ADA Curb Ramp New Construction Inspection Form (Perpendicular)

Nw 293rd

23885.56

NW Keenon

PERPENDICULAR RAMP (PR)

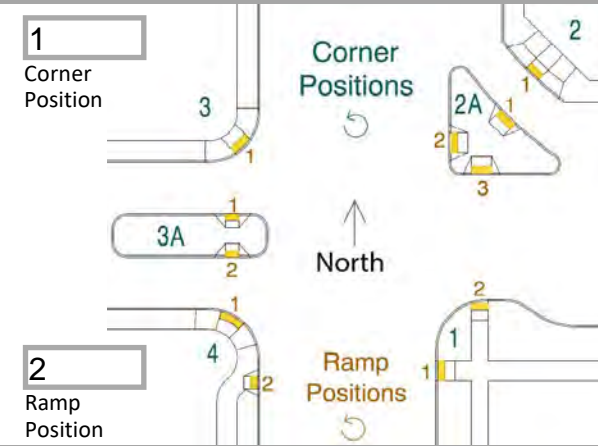
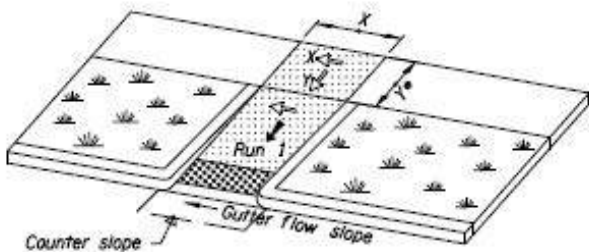
Running Slope 1

8.4

☒

Slope X

2.7

☒

Control joint center of TS
